Staff Comments Re: Files: A48/11, A01/12, B01/12, A02/12, A03/12, A04/12, A05/12 and B02/12

Resdan Holdings Ltd.
Parkway/Crawford Drive
Development
Waterloo, Ontario

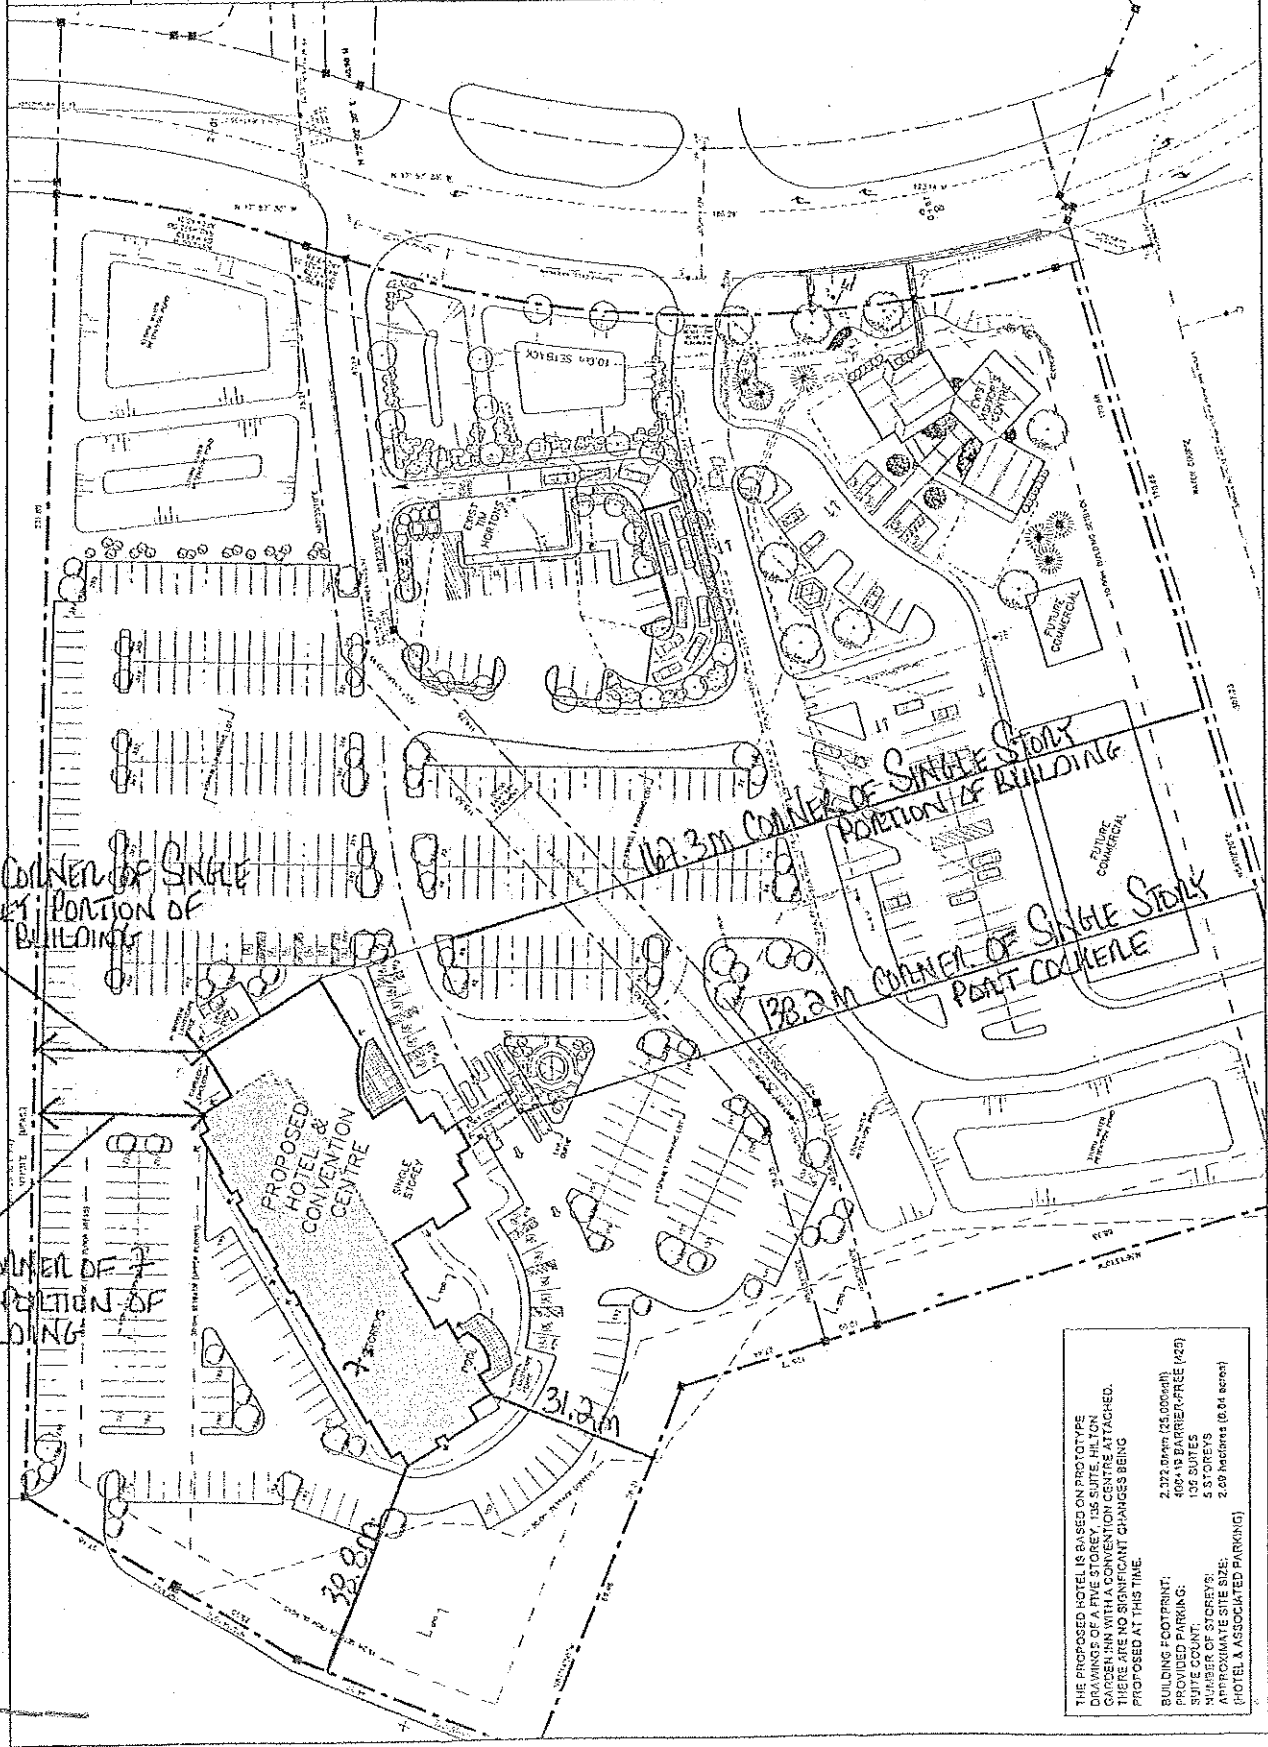
Currently the subject property is surrounded by vacant land zoned for industrial purposes, most of which is owned by the City. Staff considered the conceptual site plan for the property attached as Exhibit B and noted that the proposed setback of the building at a height of 7 storeys would be setback no less than 30 metres from any lot line.

Staff considered the potential for development of the subject property with regard to its designation, its size, the dual zoning and the intention of the zoning district to regulate the setback by way of setting the building back 4.3 metres per storey the same as the zoning on adjacent lands. Staff is of the opinion that the intention of the regulation would be maintained and the impact of a variance to allow a 7 storey commercial hotel building would be minor provided that the 7 storey portion of the building is it is no closer than 30 metres from any lot line.

Should the Committee grant the variance, staff would recommend that the variance based on the conceptual site plan provided lapse should construction of the project not begin by January 2015.

PLAN OF SURVEY OF
PART OF LOT 45
REGISTERED PLAN N° 5
CITY OF PETERB
COUNTY OF PETERI

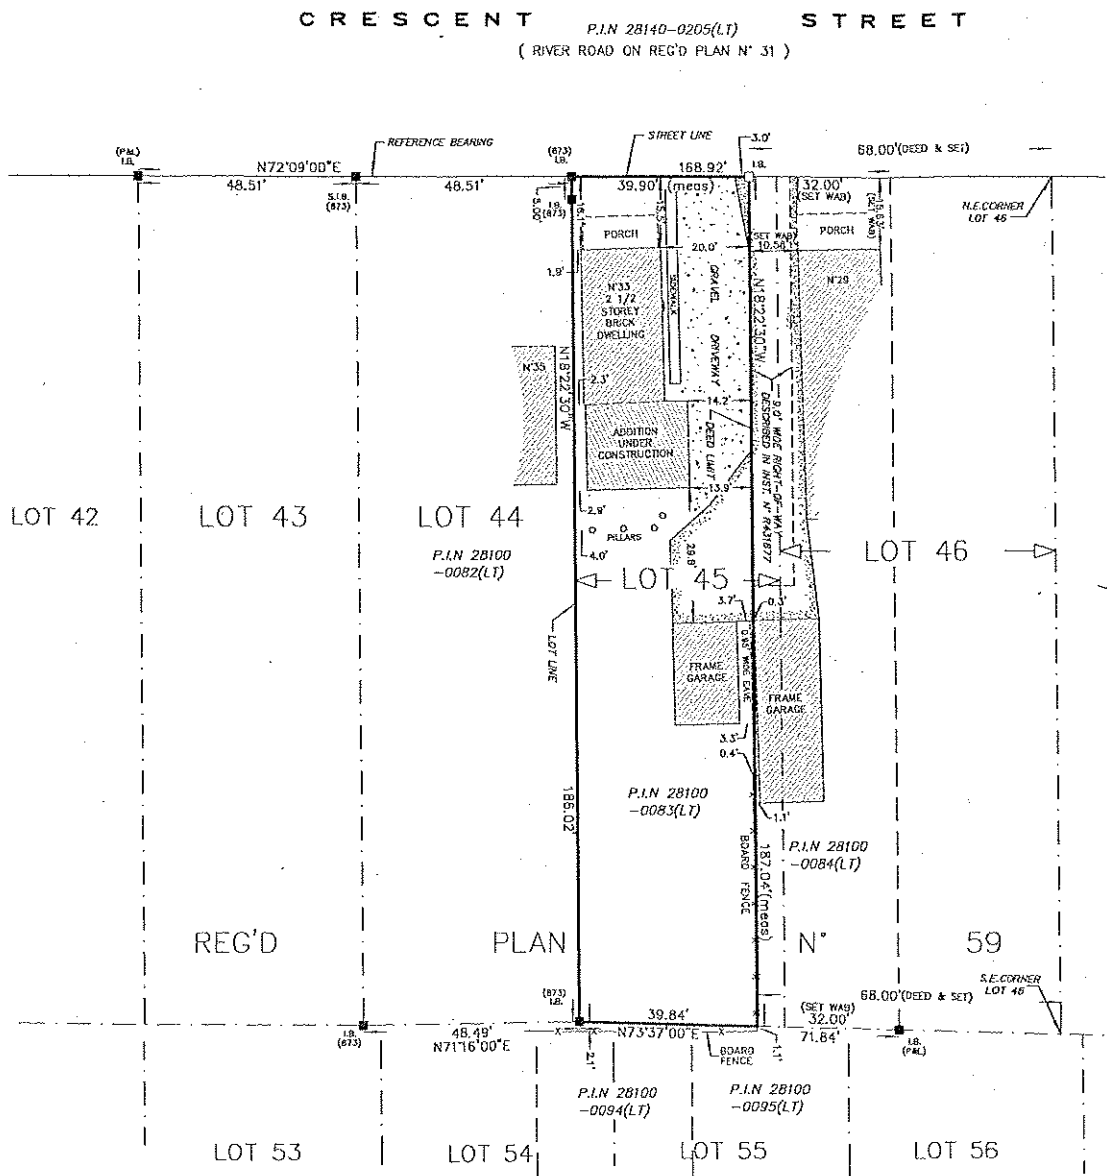
The owner is seeking relief from the required setback from the west side lot line to acknowledge the partial construction of a two storey addition to the rear of the building and the dormer in the attic of the building on the property. A variance is therefore requested to reduce the minimum building setback from the westerly side lot line from 1.2 metres to 0.57 metres (1.9 ft).

Staff have visited the subject property and reviewed the circumstances regarding the partial construction of the additions and found the following:

- 1) There was no survey information regarding the location of the dwelling as the basis upon which the building permit was issued.
- 2) Municipal records indicate that the previously existing, one storey addition to the rear of the building was located further from the lot line than the partially constructed addition.
- 3) The recently prepared survey, attached as Exhibit D, has revealed that the dwelling including the partially constructed addition to the rear is less than 1.2 metres (3.9 ft) from the west side lot line.
- 4) The dwelling on the adjacent property to the west is located approximately 1.2 metres from the common lot line adjacent to the building additions.

Considering the intent of the regulations in relation to the location of established building on the adjacent property, Staff cannot support the variance that would allow the dormer on the west side of the building. A permit cannot be issued for a structure with an “unprotected” window opening and staff is of the opinion that the dormer adds inappropriate height and building massing in close proximity to the building on the adjacent property.

Considering a variance to reduce the minimum building setback to 0.7 metres to allow a two storey addition to the rear of the building in line with the west wall of the existing building Staff would ask the Committee to be practical in using their discretion considering what is established.

Subject to concerns raised by neighbouring property owners, Staff would not object to the Committee granting the variance as described to a distance of 21.5 metres measured from the front lot line provided the west wall of the addition has no window openings.

The Committee should consider granting the variance with the proviso that the variance be null and void if the dormer on the west side of the building is not removed by January 2013.
